Office Action Summary

09/872,212

FINAL OFFICE ACTION

**FIG. 1**

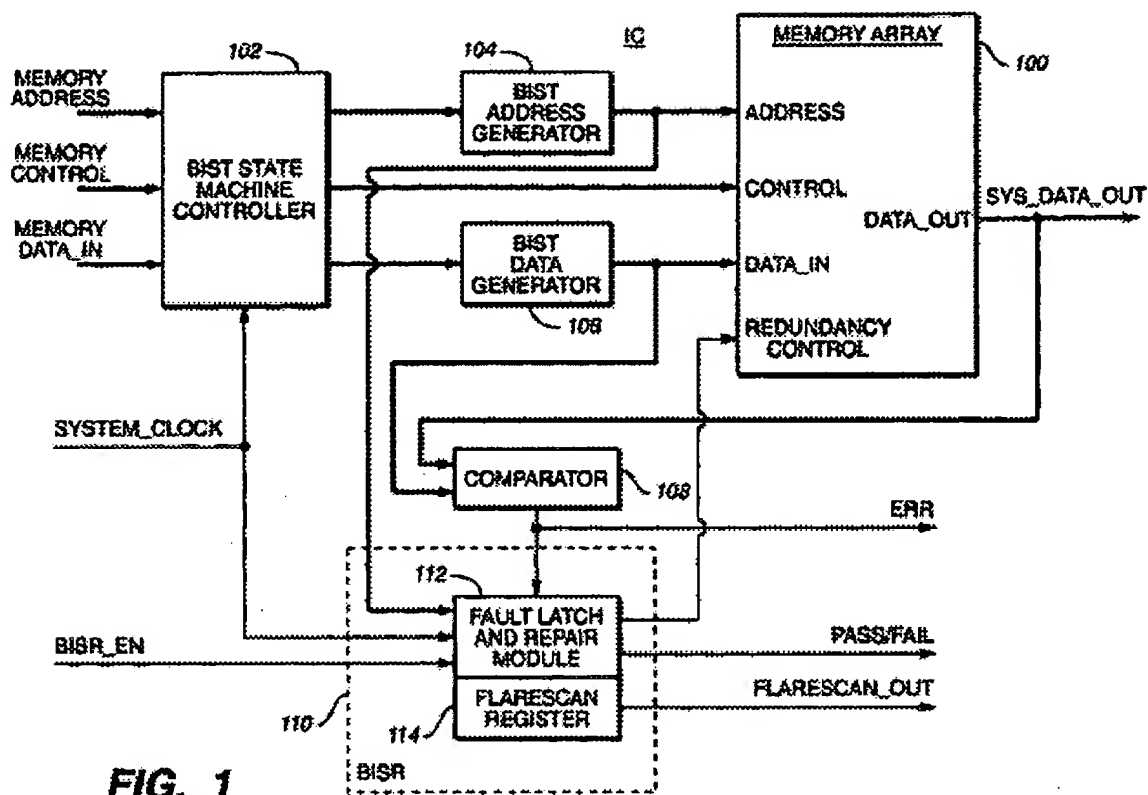
Examiner disagrees because the **admitted prior art Fig. 1** discloses a testing system wherein an automatic test equipment sequences plural memory testing tasks, such as activating a hold or pause or idle state in testing operations followed by a continue or resume state activation in testing operations via plural control means, such as hold pins, to plural BIST controllers.

Examiner notes that the claimed invention is a subset of admitted prior art **Fig. 1**: in sequential mode, the ATE activates the hold/idle/pause pin/terminals individually. However, in parallel mode the ATE activates the hold/idle/pause pin/terminals simultaneously. **Therefore, in**

In other words, the claimed invention carves out the above parallel mode of the admitted prior art **Fig. 1** and recites inherent synchronization means necessary in digital circuit operation.

Examiner disagrees because the **admitted prior art Fig. 1** discloses a testing system wherein controllers 18 are embedded in IC 14 under sync control of ATE 12.

As per Claims 1-3, 8, 12, Applicants admit as prior art the claimed IC with BIST arrangement comprising plural BIST controllers, resume/hold input external/internal pins or terminals, ATE coupling means, idle state means (page 3 line 21) and memory composed of DRAM or SRAM or ROM in **prior art** Fig. 1 and related description.

As per Claims 4-7, 9-11, 13-30, 32, 34-37, Admitted prior art substantially discloses the claimed IC with BIST arrangement comprising plural BIST controllers, resume input external/internal pins or terminals, ATE coupling means, idle state means (page 3 line 21) and memory composed of DRAM or SRAM or ROM, IDDQ/walking/testing means in **prior art** Fig. 1 and related description.
